Notice of Allowability	Application No.	Applicant(s)	
	10/783,025	SUWA ET AL.	
	Examiner	Art Unit	
	Terry L. Englund	2816

EXAMINER'S AMENDMENT

Replacement Sheets
Title: BOOSTER CIRCUIT
Atty. Docket No.: 60188-781
Inventor(s): Hisashi SUWA et al.
Serial No.: 10/783,025

FIG. 1

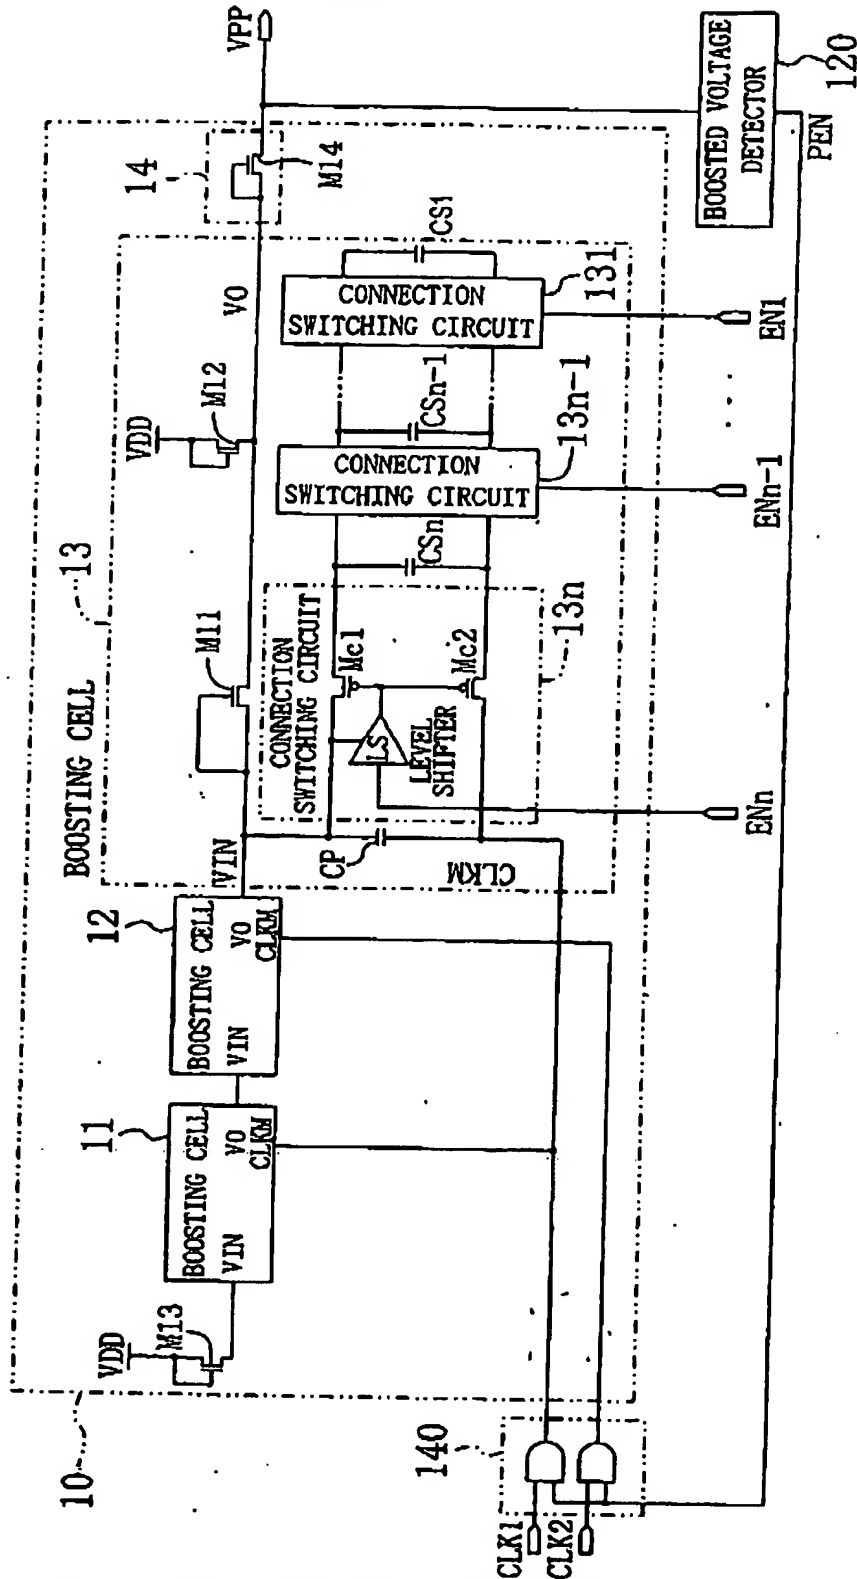
The examiner has approved the replacement sheets for Figs. 1, 4, and 6. They overcame the drawing objections described in the previous Office Action, which have now been withdrawn.

Approved
1.4.06
TLE
